## RECEIVER & COCKPIT

In 2007 the receiver and cockpit programming was changed in the RAMMAX HHMR and FCR.

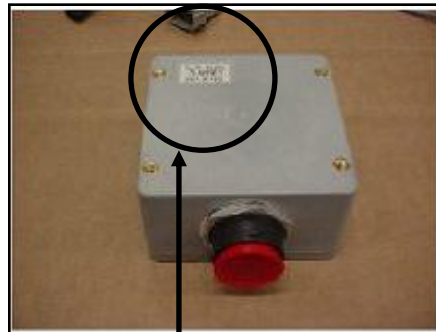
Both receiver and cockpit must have the same designation on the components or they will not properly communicate with each other.

Notice the label on the back of each component. The receiver has **Rec 07** and the cockpit has **Cockpit 07**. This verifies the two will communicate with each other.

If your machine is in need of a replacement receiver or cockpit, check the original components labels before ordering.
